RE: Docket No. 40-6563
TAC No. L51568
NRC License STB – 401

Responses to NRC Request for Additional
Information about Mallinckrodt's C-T Phase II
Decommissioning Plan

RAI Group 1
August 1, 2005

Responses to NRC Inquiries About C-T Phase II Decommissioning Plan

Figure 42. Frequency Distribution of Respirable Dust in Urban Air
(EPA AIRS PM-10 data normalized to urban environment)

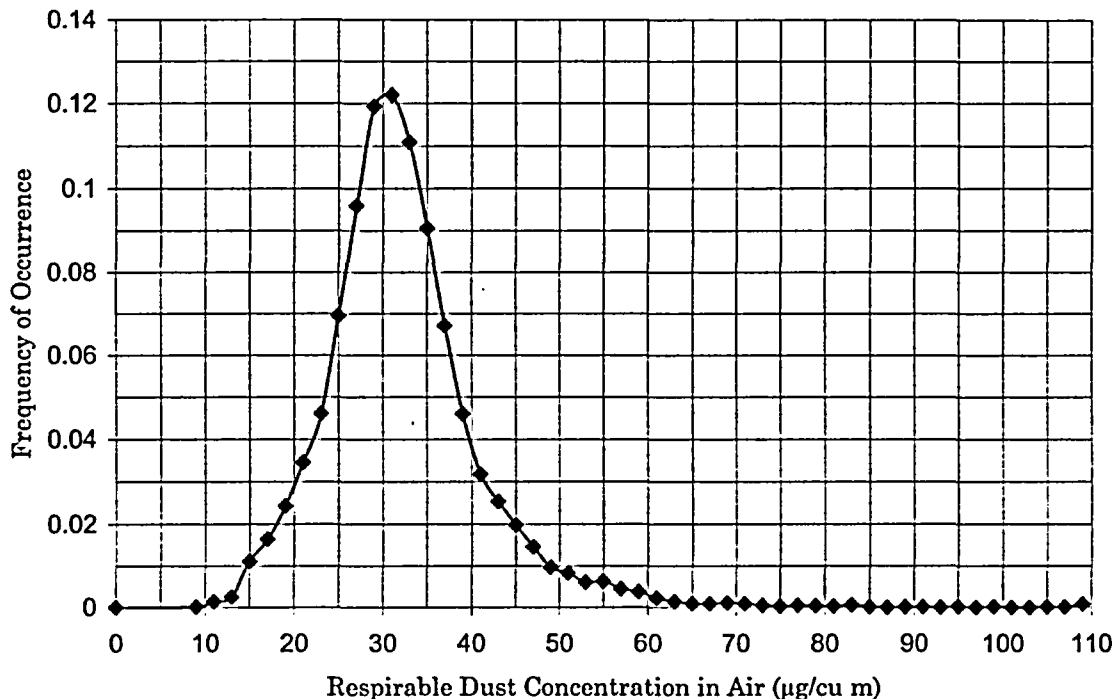
42. (b) The mass loading for inhalation factor: the licensee used a factor of $3.500\text{E-}05 \text{ g/m}^3$ for the industrial worker scenario and a factor of $8.0\text{E-}05 \text{ g/m}^3$ for the construction/excavation worker scenario. The RESRAD default value is $1.00\text{E-}04 \text{ g/m}^3$. The licensee used references with ranges of mass loading factor. Since the value for this sensitive parameter is uncertain, this parameter could be better represented as variable with a distribution between the two limits $5.0\text{E-}04$ and $2.3 \text{E-}05 \text{ g/m}^3$. Alternatively, the licensee may select a more conservative value to bound the variable site conditions within the 1000 years performance period.

A distribution representing airborne particulate loading in urban air may be estimated by the shape of the distribution in NUREG/CR-6697, Table 4.6-1 and Figure 4.6-1, shifted upward by an increment representing the increase in dust in urban air relative to all ambient air. The result, in Figure 42, becomes the probabilistic distribution to replace the default distribution in RESRAD v. 6.22. This distribution represents careful, reasonable appraisal of values of airborne respirable mass loading in an urban environment. Derivation of DCGL_w in soil are being derived by probabilistic modeling using this distribution of respirable particulate density in air.

Figure 43A. Fraction of Gamma Dose Rate Penetrating a Concrete Floor
source ratio: 3 U series + 0.1365 U235 series + 1 Th series; one meter deep in soil

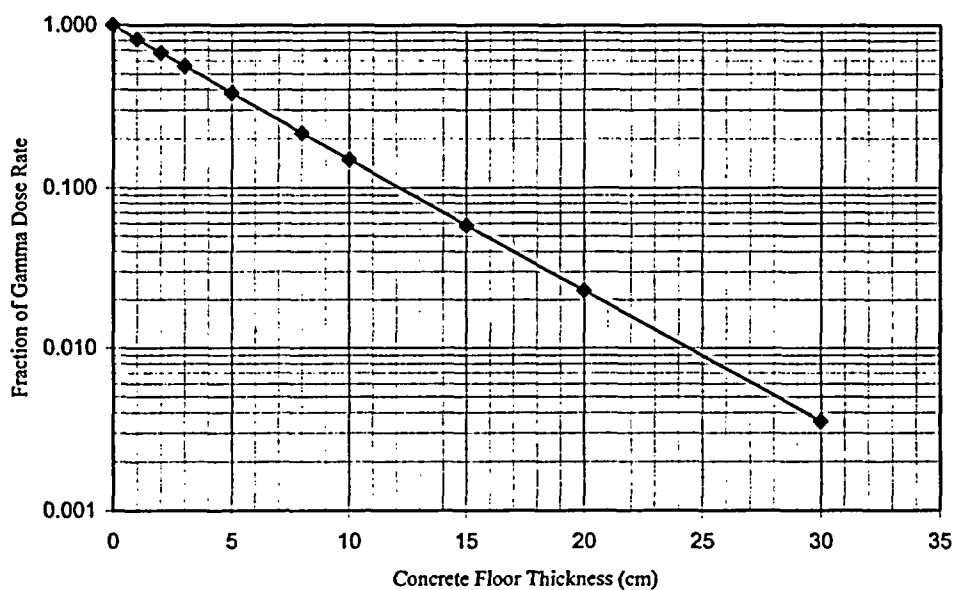
43. (c) The licensee selected an indoor gamma shielding factor of 0.17. In other words the licensee assumed that only 17% of outdoor gamma radiation can be penetrated indoors. The RESRAD default value is 0.7. The licensee indicated that Plant 5 has concrete slab floors or concrete walls with few windows. Therefore, the licensee assumed that the factor 0.17 should represent the gamma shielding for the building flooring and walls. It should be noted that the performance period for decommissioning is 1000 years. Therefore, the assumption that concrete floors and walls will be always available and well maintained to shield from gamma radiation is unrealistic. For example, prefabricated buildings may be constructed on the contaminated soil with minimum shielding from walls and floors. Further, a security guard may be located at the entrance of the building with much less shielding from outdoor gamma radiation. It should be noted that the shielding factor for the construction worker was conservatively selected as 1.0; however, the shielding factor for the industrial worker scenario is not well justified. This important sensitive parameter could be better represented as variable with a distribution between the two limits 0.17 and 0.7. Alternatively, the licensee may select a more conservative value for the shielding factor to bound potential site-specific conditions within the 1000 year performance period.

On the premise that a floor construction is likely to be specified in an integer thickness in units of inches, a *discrete cumulative* probability distribution of these data has been specified in RESRAD. Figure 43A summarizes the fraction of dose rate from gamma radiation penetrating a concrete floor as a function of its thickness. Figure 43B depicts the cumulative probability and indoor gamma shielding factor data entered into RESRAD for probabilistic evaluation of the effect of this parameter on radiological dose rate.
